MEMORANDUM

SUBJECT: Staff Analysis of Conceptual Plan CP 86-C-119-3
Boston Properties, Inc.

Title of CP: Reston Gateway, Section 93, Blocks 1 and 2.
Prepared by: Davis • Carter • Scott
Dates: February 4, 2000 revised through July 7, 2000

DRAWING TITLE
LANDSCAPE PLAN

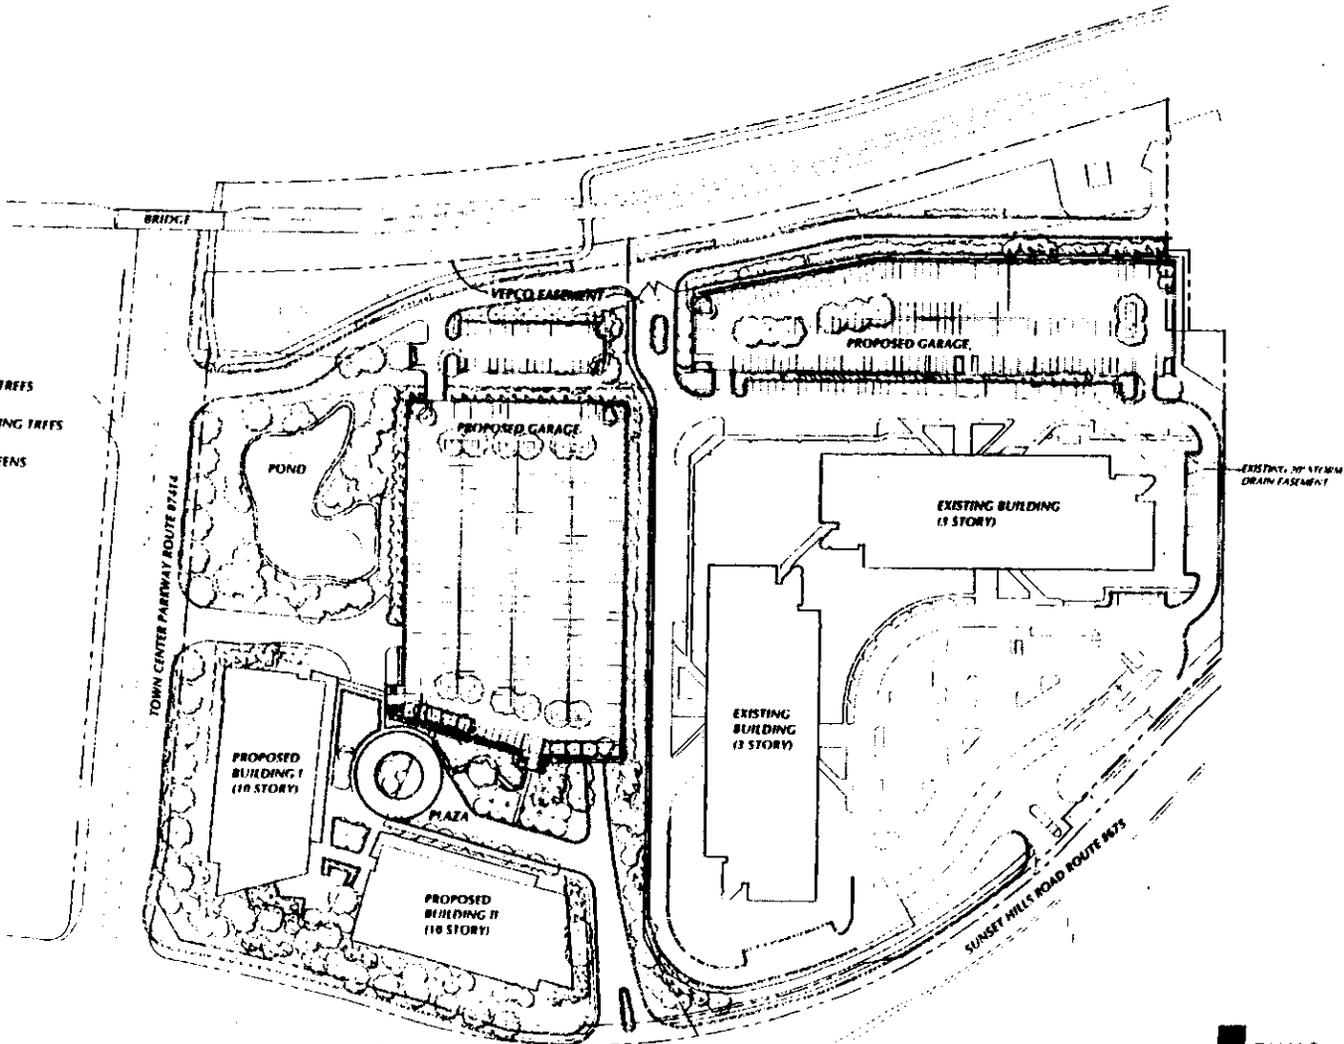
1. **Comment:** The concept landscape plan (sheet CP-9) proposes, large flowering trees, however, the species indicated on sheet CP-10 are small to medium deciduous trees. Very few large deciduous trees are proposed for areas adjacent the two access roads to the proposed six-level parking garage. Large deciduous trees shading these paved surfaces could be credited toward the interior parking lot landscaping requirement. Proposed landscaping provides minimal shade for parking spaces proposed along the south side of the four-level garage and the surface parking adjacent the Virginia Power easement.

Recommendation: Revise the concept landscape plan to show large deciduous trees to provide shade for the access roads leading to the drop off point in the proposed plaza (see Plaza Details, Sheet CP-10) and to the proposed six-level parking garage. In addition, show large deciduous trees in islands within the row of parking spaces proposed along the southern side of the proposed four-level parking garage and the surface parking adjacent the Virginia Power easement. Provide at least eight feet between proposed walkways and paved surfaces for proper planting sites for large deciduous trees.

DRAWING TITLE
PLAZA DETAILS

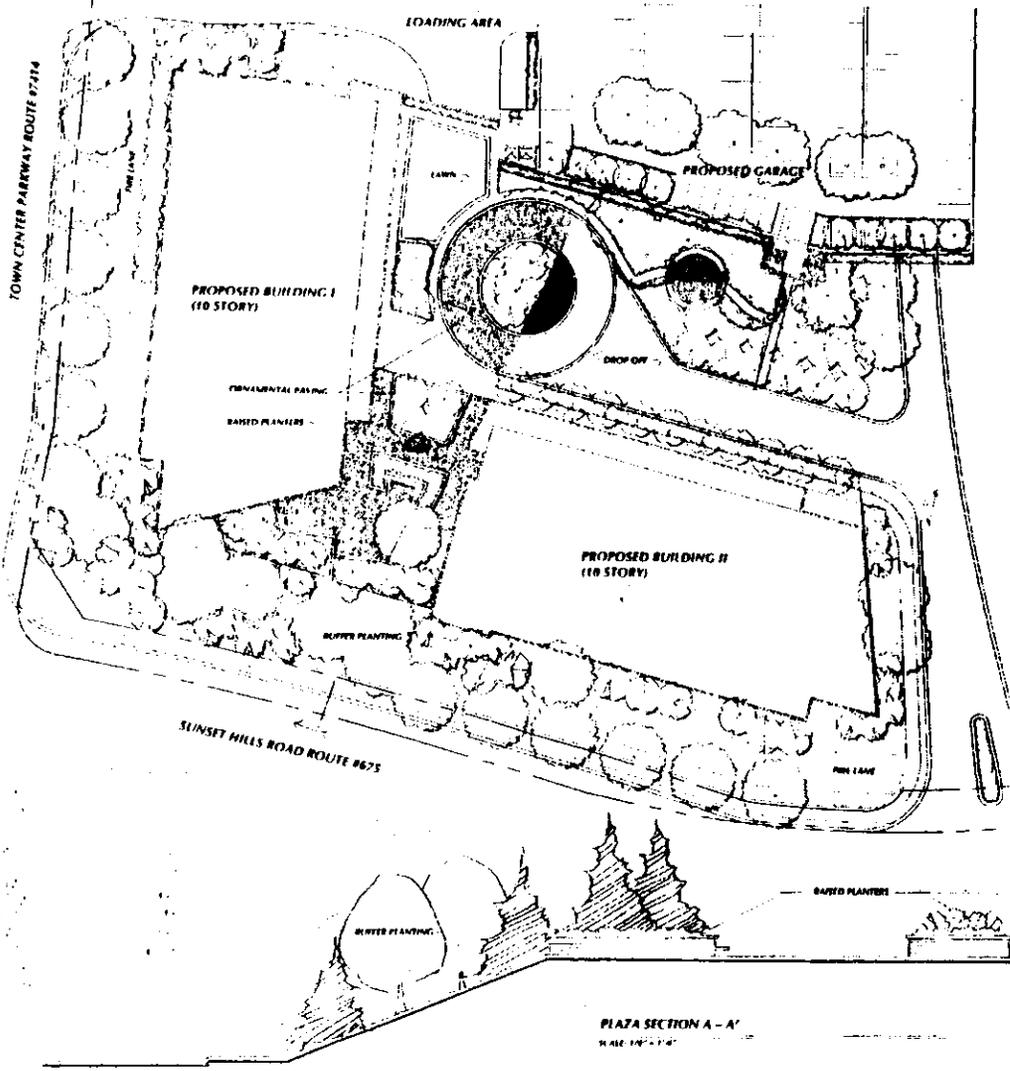
In response to these issues, the applicant submitted a revised conceptual landscaping plan which shows landscaping treatments and a range of plant material to be utilized throughout the site. A detail was provided on Sheet 10 which depicts proposed landscaping treatments for the building entrance courtyard and a plaza between the two buildings. It should be noted that Note 32 of the Plan Notes, gives the applicant the right to connect the two buildings with either a landscaped plaza area as depicted on Sheet 10, an atrium or an enclosed structure either above or below grade. The applicant commits that any connection shall be architecturally compatible with the proposed office buildings and will include appropriate landscaping treatments. Staff continues to recommend that the applicant commit to provide either the landscaped plaza as shown on the Conceptual Plan or an atrium with extensive landscaping treatments in the interior in order to soften the appearance of the buildings from the roadway. Staff also recommends that the applicant commit to provide additional landscaping within the Virginia Power easement along the northern perimeter of the site to soften the visual appearance of the access road and provide some shade along the trail which will connect to the W&OD trail.
